<i>Dealer Operator / General Manager</i>	<i>Sales New Vehicles</i>	<i>Sales Used Vehicles</i>	<i>Business Manager (F&I)</i>	<i>Service</i>	<i>Parts & Accessories</i>	<i>Administration</i>
Date: Bulletin #	Dec 4, 2017 SV-ZMC-018-380	Source: Phone #:	Zero Motorcycles Aftersales Department US: (888) 786-9376 Ext. 2			Program Period: Commencing December 4, 2017

SERVICE BULLETIN: 2018 Vehicle Emission Control Information (VECI) Label Recall

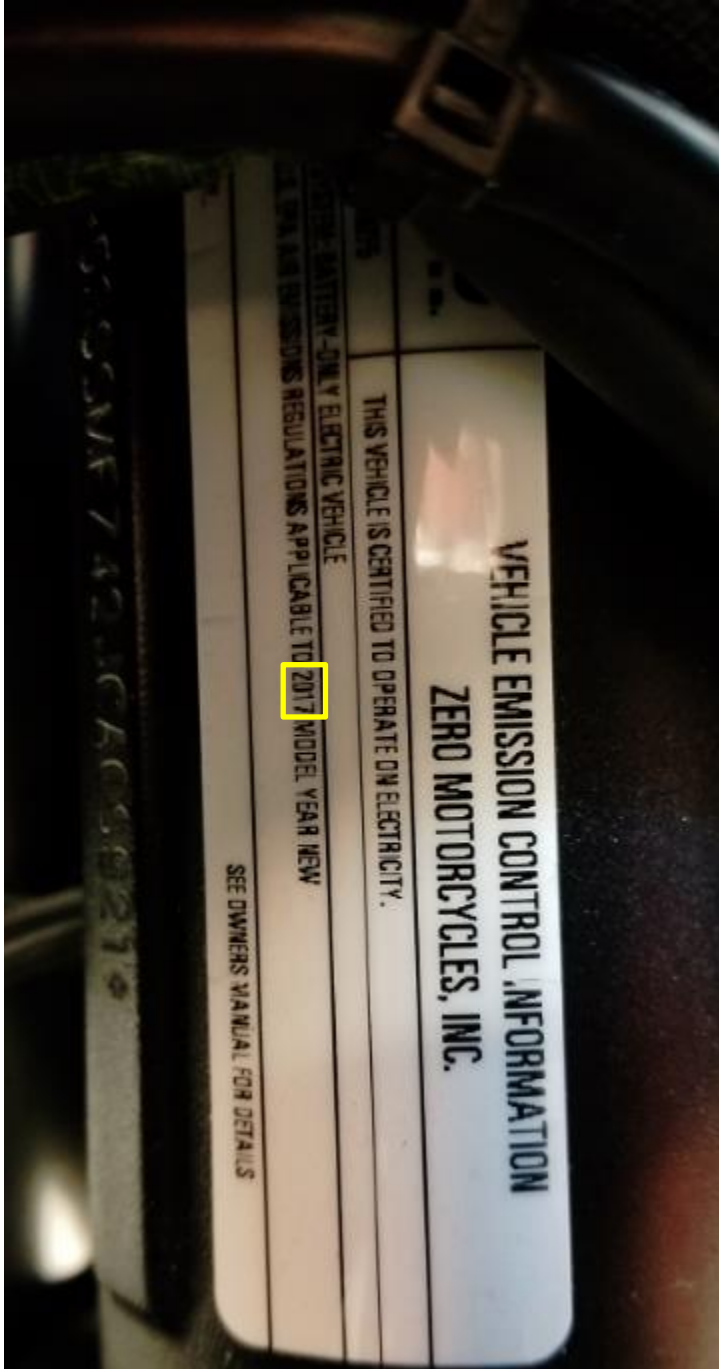
Zero Motorcycles has determined that a defect which relates to motor vehicle regulatory compliance exists on 2018 Model Year motorcycles built between September 05, 2017 and October 12, 2017. Due to a data input error, the VECI labels on the subject motorcycles are not compliant to regulations FMVSS 571.108 S9.3.6. The labels incorrectly state the model year as 2017 instead of 2018.

1. Verify incorrect label

The remedy of this defect is for Zero Motorcycles dealers to remove the incorrect label and replace it with a corrected label, supplied by Zero Motorcycles.

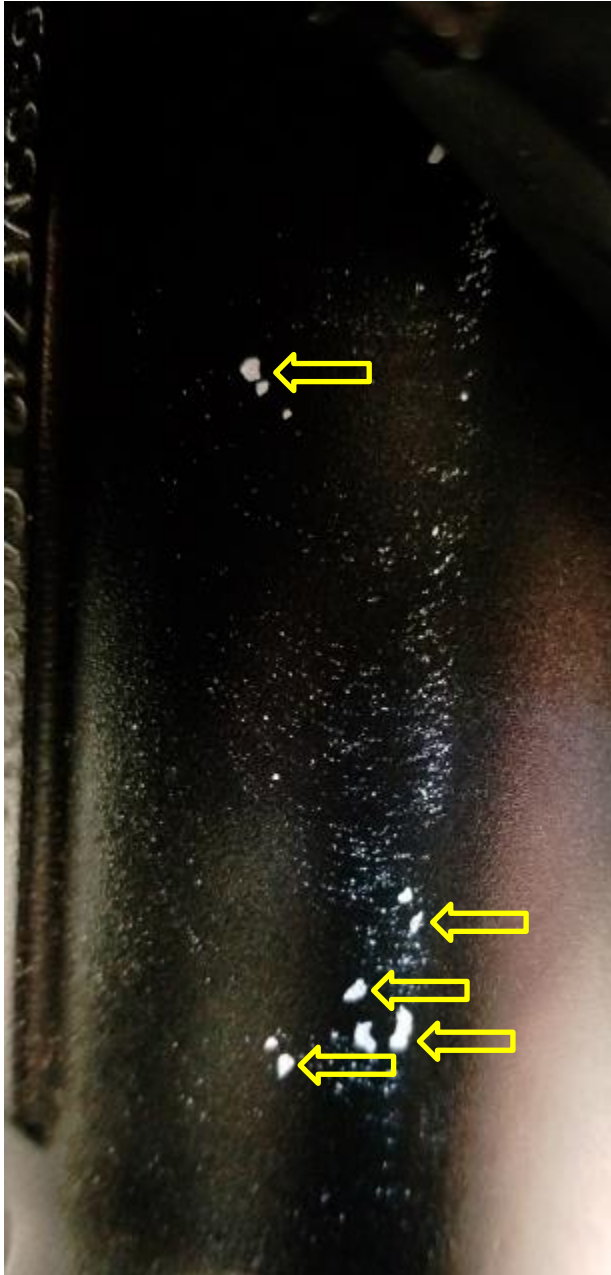
2. Peel label from frame
3. Clean remaining "void" remnants from frame

4. Apply new correct label (verify correct Engine Family)
S ZF7.2 / FX – FXS ZF7.2

S – DS ZF13.0 - SR – DSR ZF14.4
